RE: DCI2018-00003 The Pine Island 7-11 CPD

In response to the issues raised at the HEX, please see attached the updated list of deviations, a revised schedule of deviations and an updated Master Concept Plan. We are withdrawing Deviation #1 (driveway separation) and Deviation #3 (relief from right-of-way buffers along Nikkis Lane) and we have eliminated the uses from schedule of use as recommended by staff, but we would still like to leave the Self-Service Fuel Pumps in the list. We are also proposing four new conditions per the discussions at the HEX. Also note the MCP has been revised to reflect the two deviations being withdrawn and the location of the new potential lot line split.

LIST OF DEVIATIONS AND JUSTIFICATION

MASTER CONCEPT PLAN

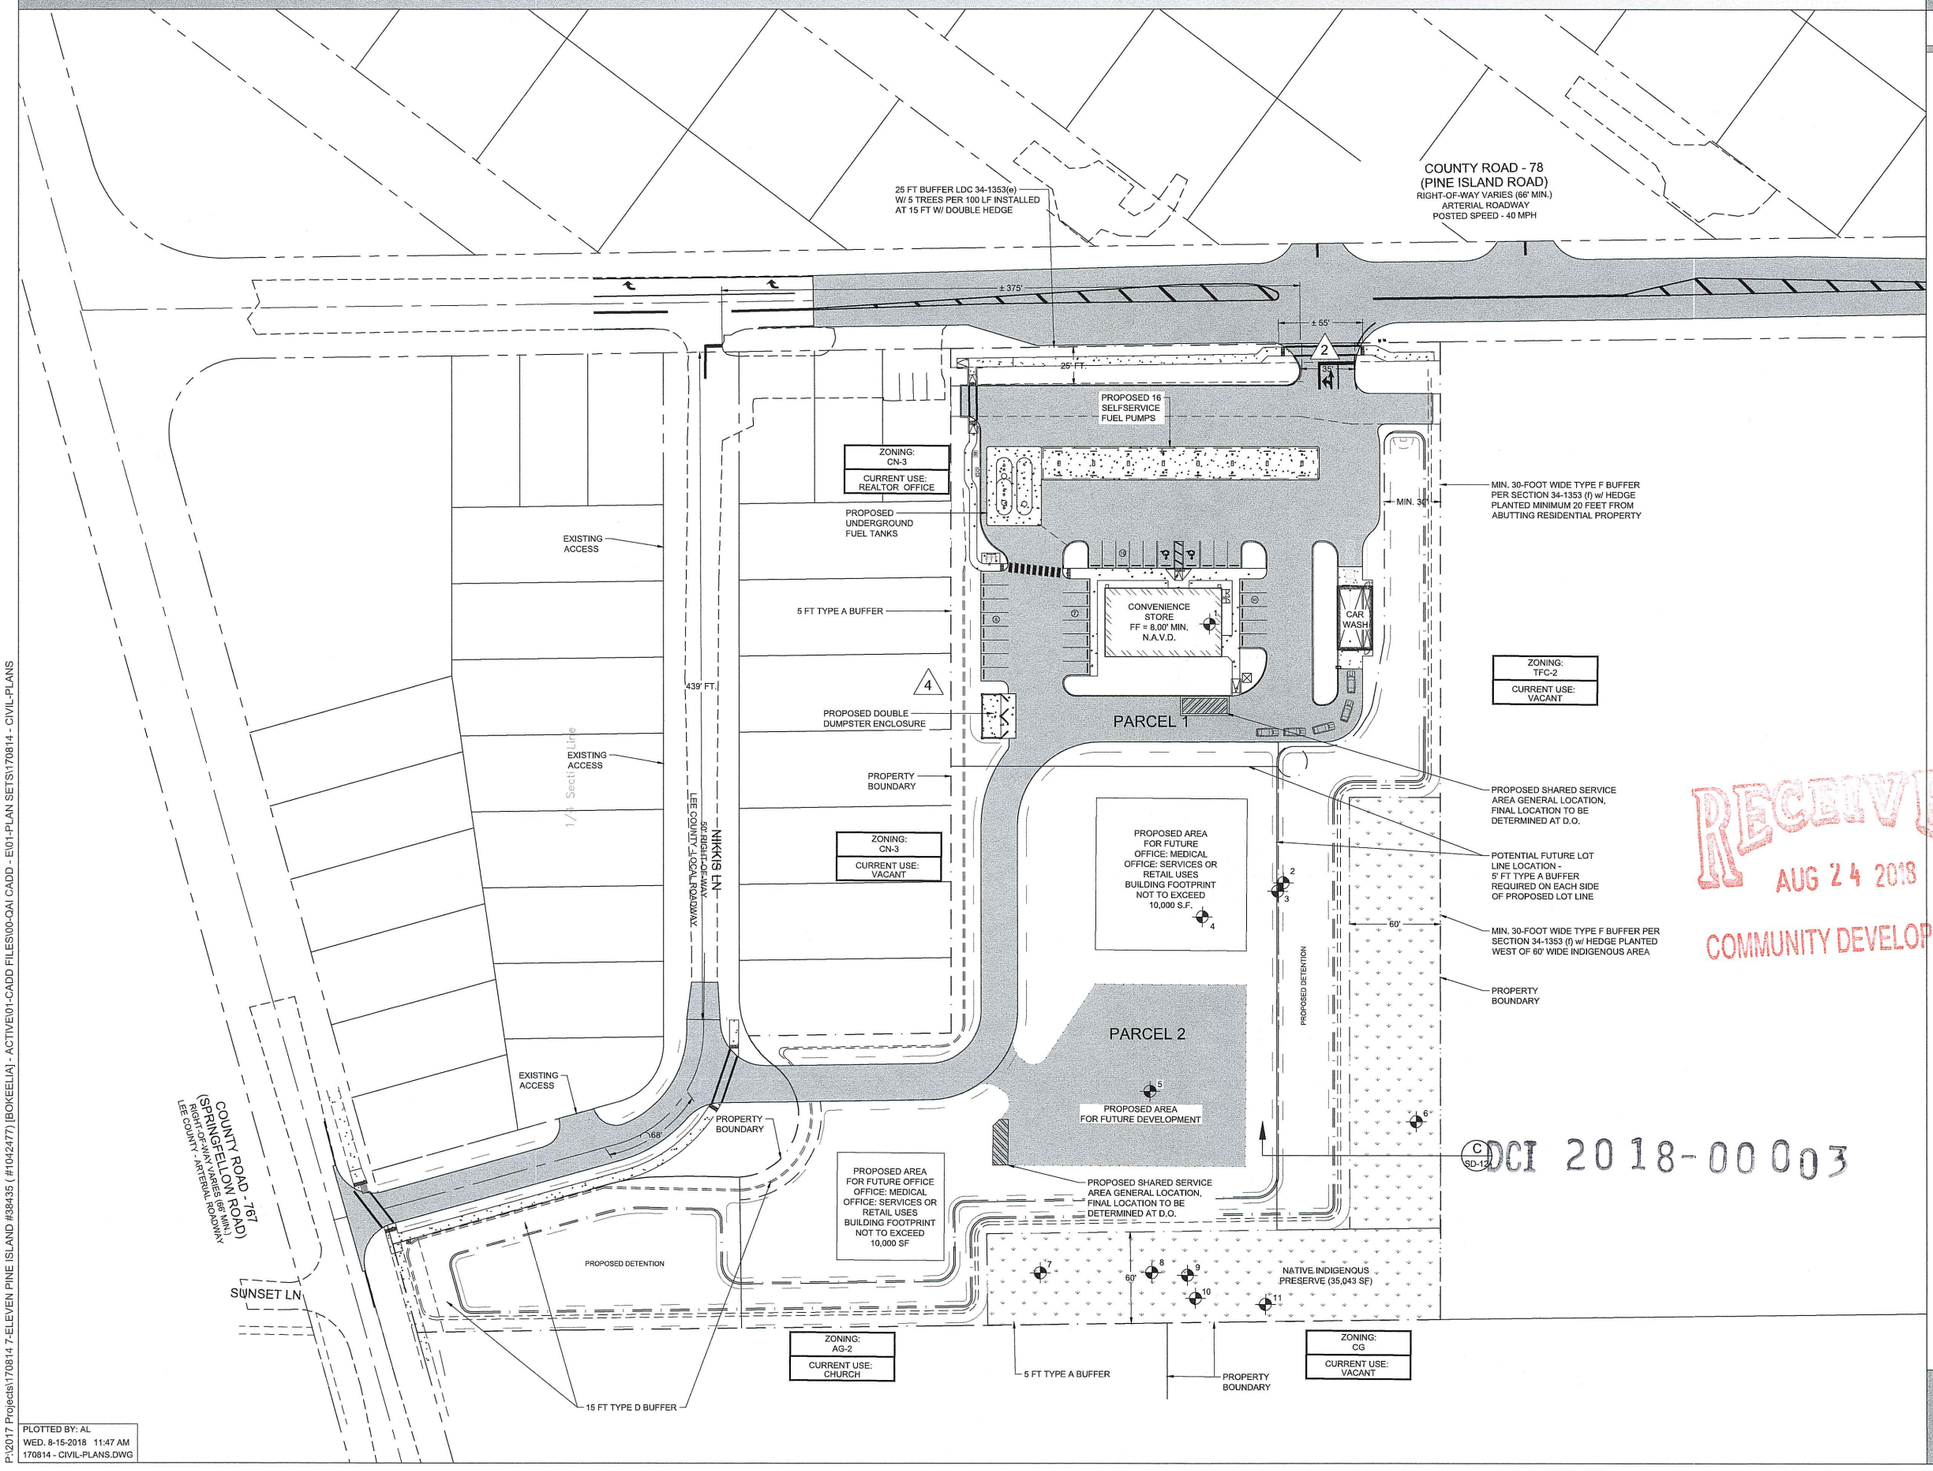
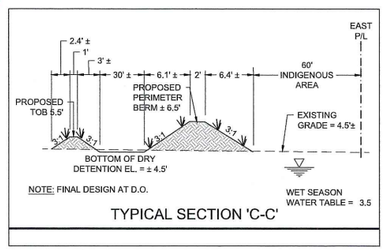
1 DEVIATION #1 - WITHDRAWN

2 DEVIATION #2 - LDC:34-2013(b)(3) ACCESS, TO INCREASE MAXIMUM DRIVEWAY WIDTH AT THE PROPERTY LINE FROM 35 FEET TO 55 FEET.

3 DEVIATION #3 - WITHDRAWN

4 DEVIATION #4 - LDC:10-295 STREET STUBS TO PROVIDE INTERCONNECTION TO PARCELS ADJACENT TO PINE ISLAND ROAD BUT NOT COMMERCIAL LOTS ON NIKKIS ROAD.

MASTER CONCEPT PLAN

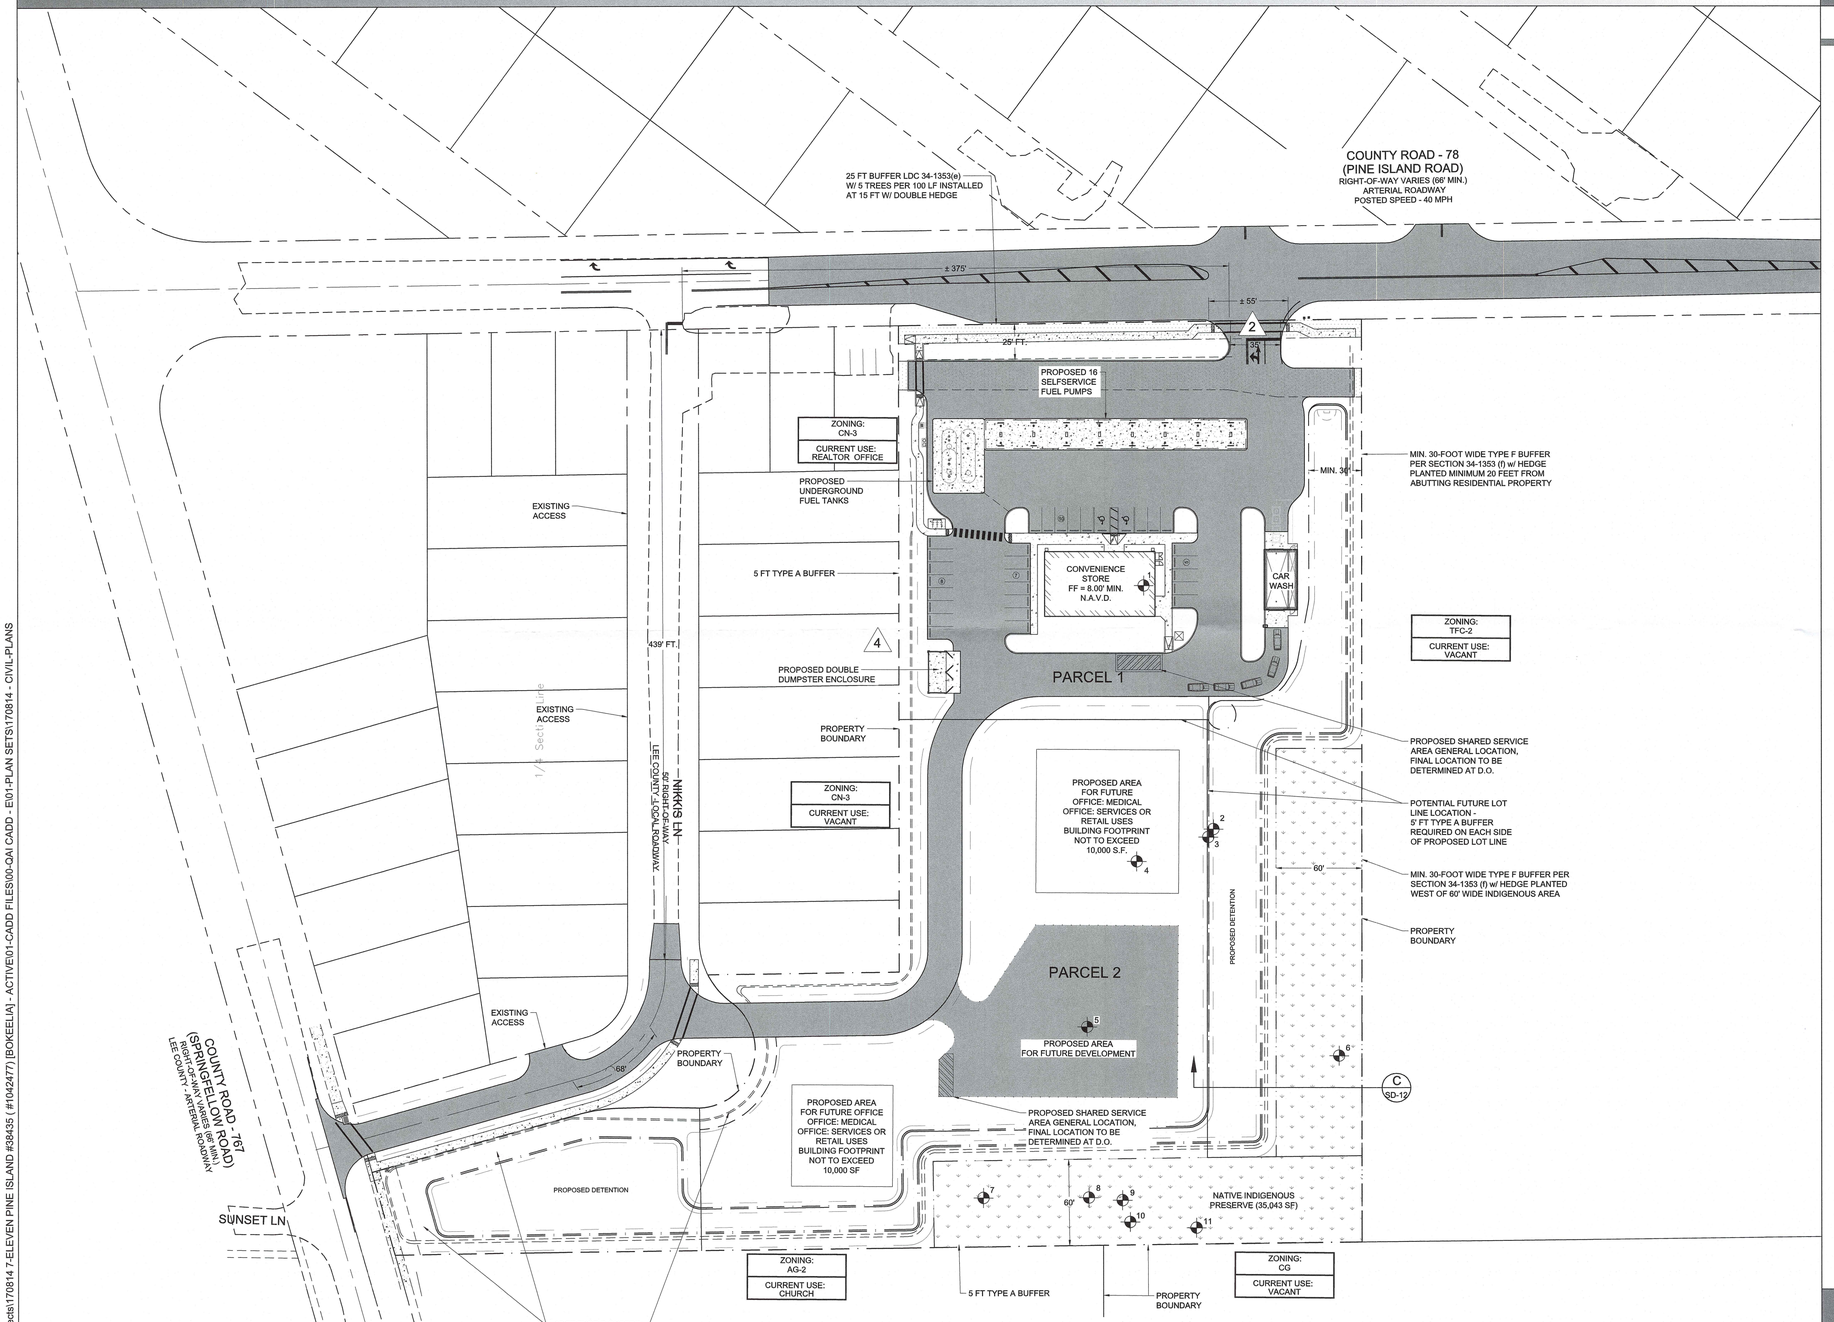
1 DEVIATION #1 - WITHDRAWN

2 DEVIATION #2 - LDC:34-2013(b)(3) ACCESS, TO INCREASE MAXIMUM DRIVEWAY WIDTH AT THE PROPERTY LINE FROM 35 FEET TO 55 FEET.

3 DEVIATION #3 - WITHDRAWN

4 DEVIATION #4 - LDC:10-295 STREET STUBS TO PROVIDE INTERCONNECTION TO PARCELS ADJACENT TO PINE ISLAND ROAD BUT NOT COMMERCIAL LOTS ON NIKKIS ROAD.
